Amendment to the Drawings:

Title of Invention: ACTIVE MATRIX ORGANIC LIGHT EMITTING DIODE FLAT PANEL DISPLAY
 Inventor: Ronald S. Cok; USSN: 09/858,109

FIG. 1
(PRIOR ART)

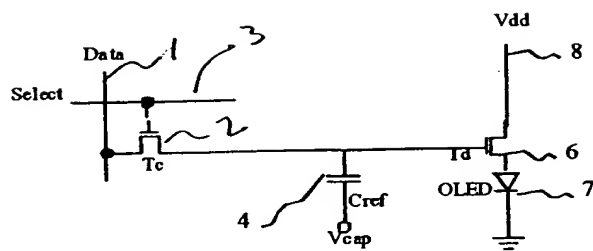
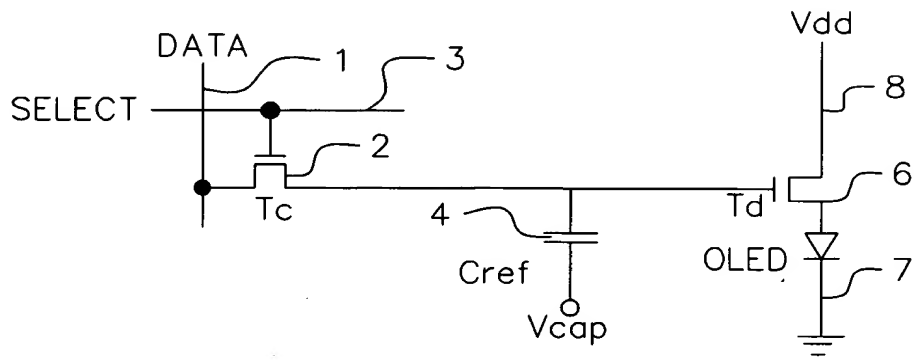
The attached sheet of drawings includes changes to Figure 1 (Fig. 1)
This sheet replaces the original Fig. 1. Formal drawings are submitted herewith under
separate Letter to the Draftsperson which incorporate the changes required by the
Examiner. Approval by the Examiner is respectfully requested.
